Work Order ID 122986

Item Name: Blade

ENGINEERING CHANGE NOTICE NO. 02195		SHEET 1 OF 4	
DWG NO. 646.3000	REV: N/C	PREPARED BY S. HUFF	DATE: 01/05/09
EFFECT ON DWG <input type="checkbox"/> INC. <input checked="" type="checkbox"/> UNINC.			
DWG TITLE: LOWER CUTTER ASSY			
APPROVED BY:	ENGR. <i>[Signature]</i>	MFG. <i>[Signature]</i>	QC <i>[Signature]</i>
			EFF: NEXT ORDER
REASON: REMOVED RIVETS IN FAVOR OF ADDITIONAL SCREWS			
TRANSACTION CODES (TC): A-ADD C-CREATE R-REVISE D-DELETE

LOWER CUTTER ASSY

SHEET 1, ZONE D5, IS:

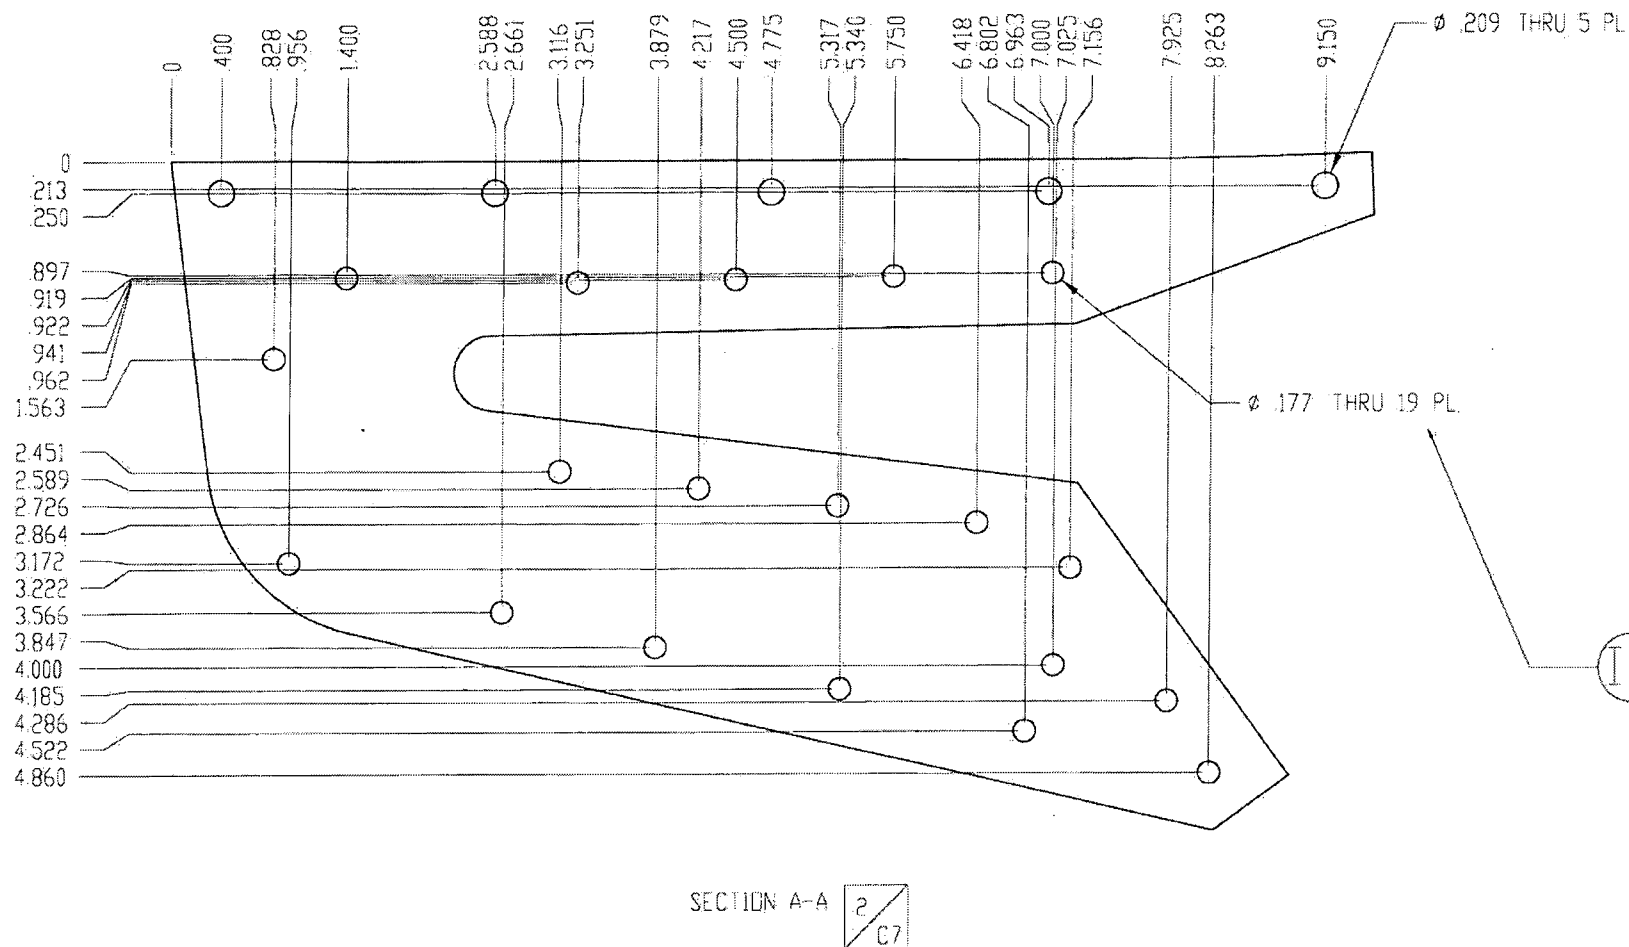
10	R	601.1541	19	LOCKNUT	MS21042L08
9	R	601.2764	38	WASHER	NAS1149FN832P
8	R	601.2765	19	SCREW	MS27039-0819
7	D	601.2766	2	RIVET	MS20470AD5-18
			.3001		
F/N TC	PART NUMBER	QTY	DESCRIPTION	MATERIAL/SPECIFICATION	
DOCUMENTS EFFECTED:				CHANGE CATEGORY	DER REVIEW REQUIRED
<input type="checkbox"/> MDL <input checked="" type="checkbox"/> INSTALL INSTRUC <input checked="" type="checkbox"/> ICA <input type="checkbox"/> FMS <input checked="" type="checkbox"/> BOM				<input type="checkbox"/> MAJOR <input checked="" type="checkbox"/> MINOR	<input type="checkbox"/> YES <input checked="" type="checkbox"/> NO

SHEET 3 IS:

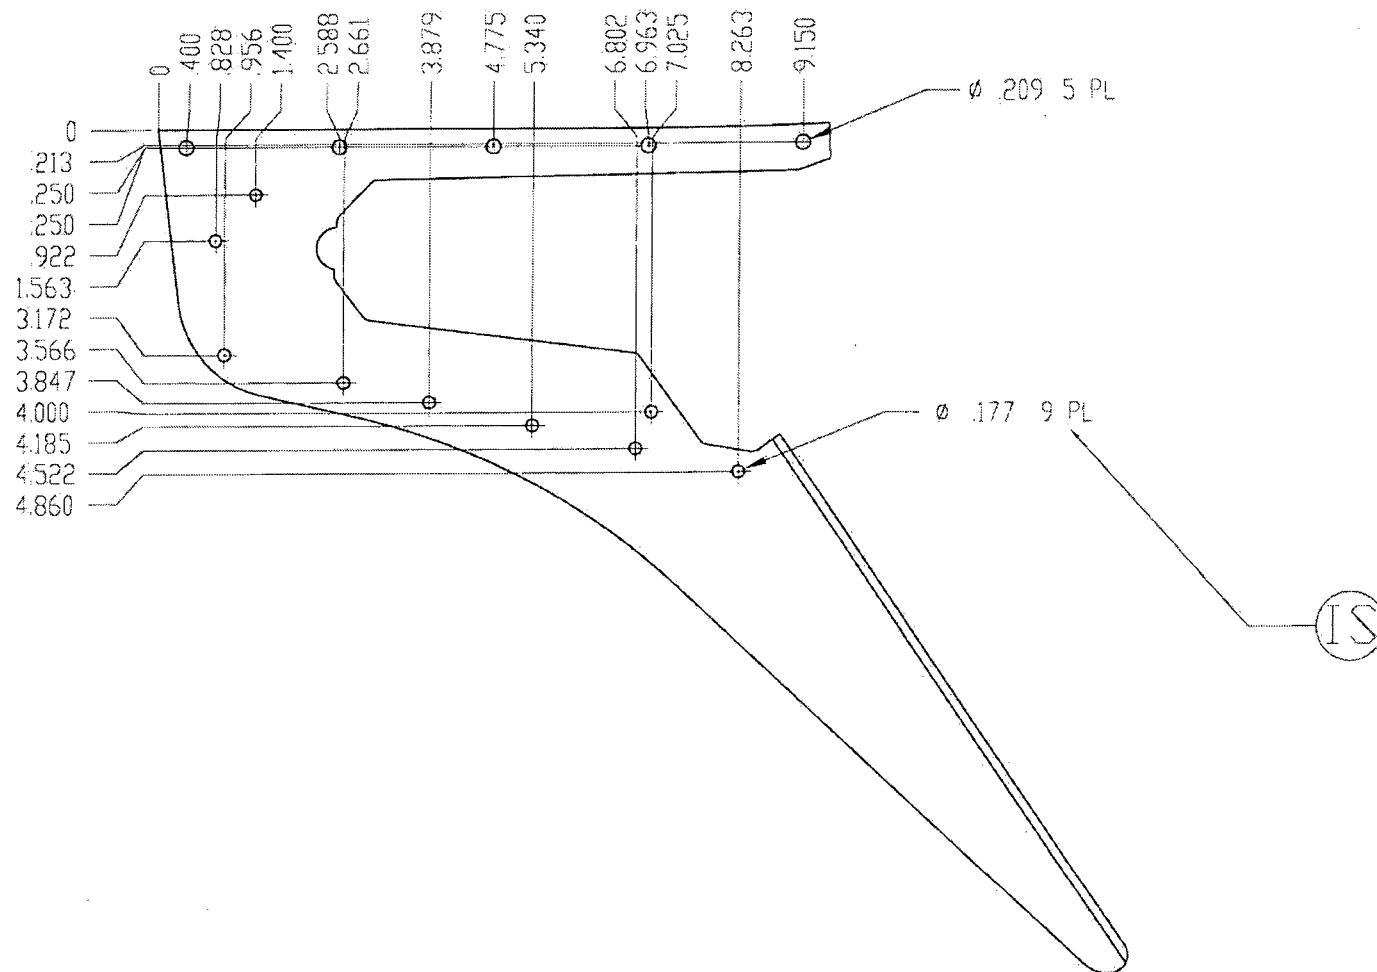
F/N	TC	PART NUMBER	QTY	DESCRIPTION	MATERIAL/SPECIFICATION

SHEET 5 IS:

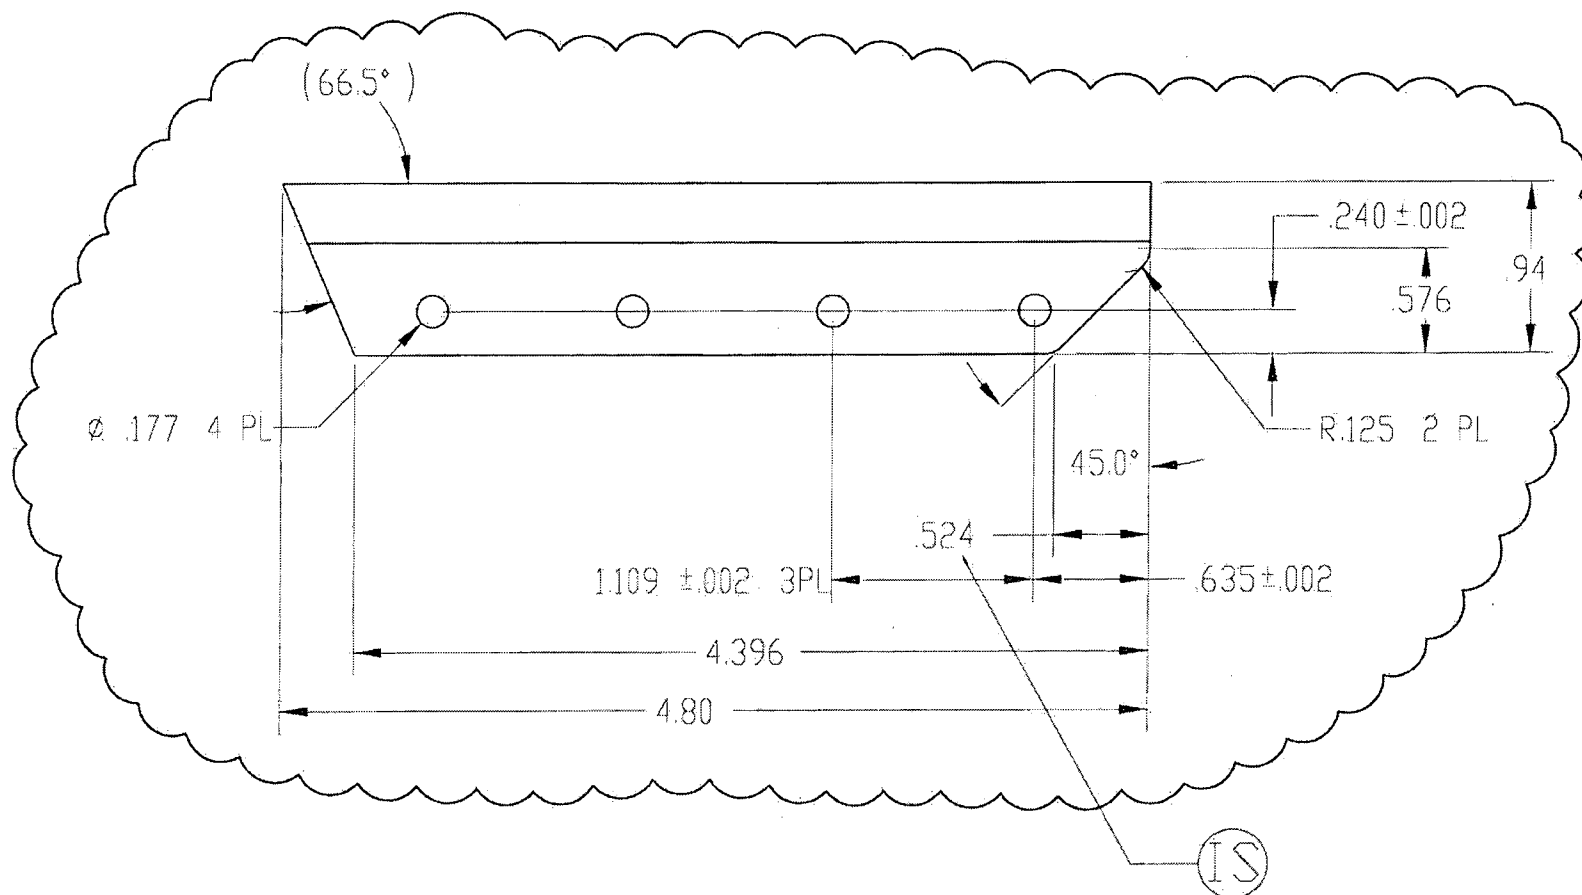
SECTION F-F

F/N	TC	PART NUMBER	QTY	DESCRIPTION	MATERIAL/SPECIFICATION

SHEET 6, ZONE C4, IS:

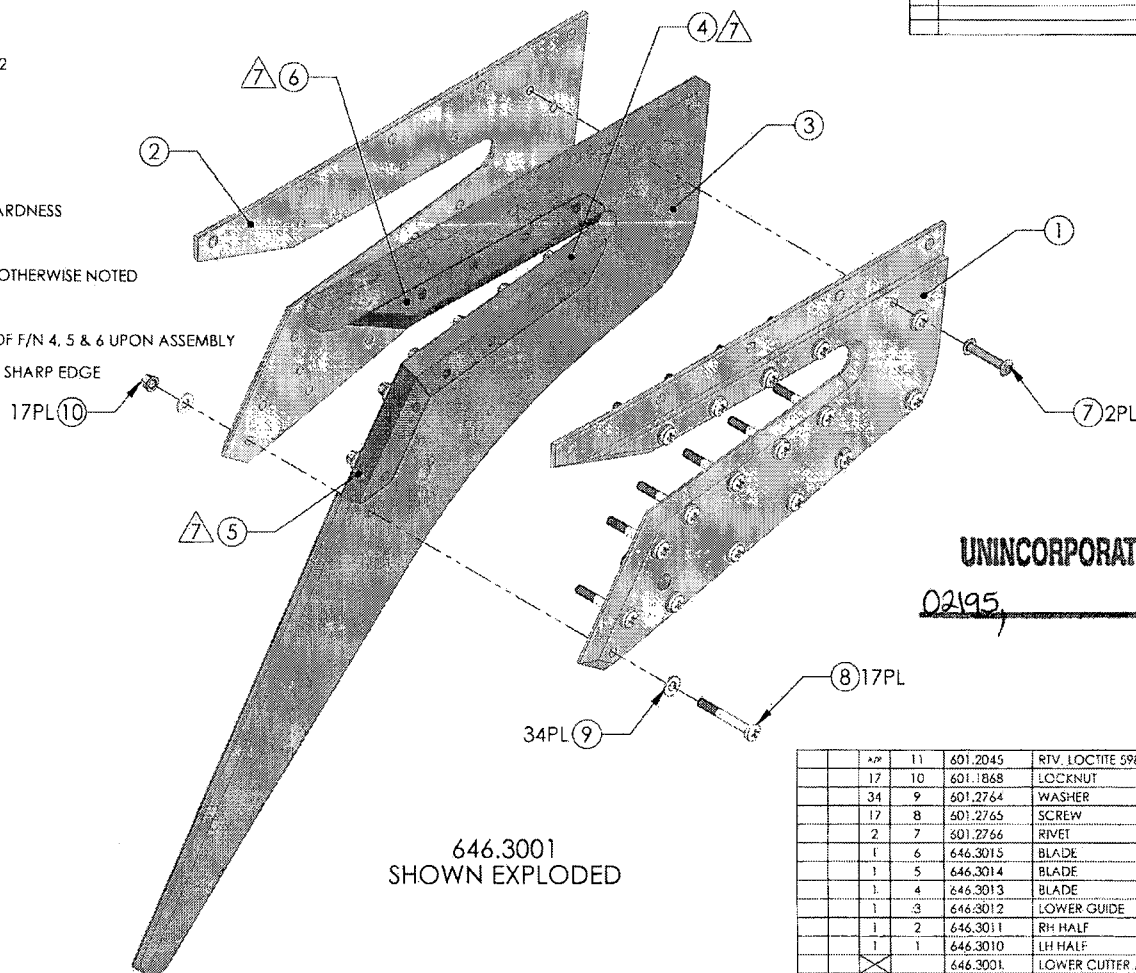
F/N	TC	PART NUMBER	QTY	DESCRIPTION	MATERIAL/SPECIFICATION
